TECHNICAL SERVICE BULLETIN

Bulletin Number: I-15-03 A/B
Model Year(s): 2016

SUBJECT: 2016 Indian Scout Motorcycles – VECI Decal Replacement

SERVICE BULLETIN COMPLETION DECAL:

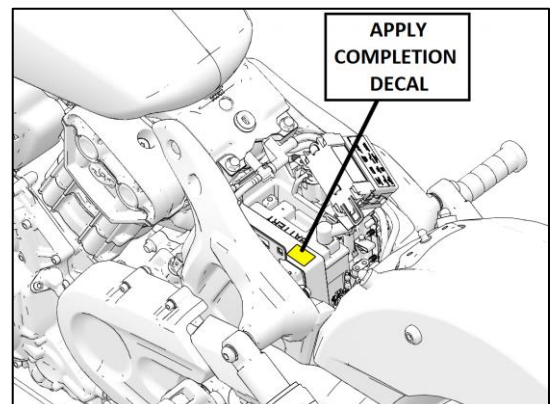
A Service Bulletin Completion Decal must be completed for this bulletin repair. Place the decal on the unit as shown (on battery bracket). Completion decals are available through normal parts ordering channels.
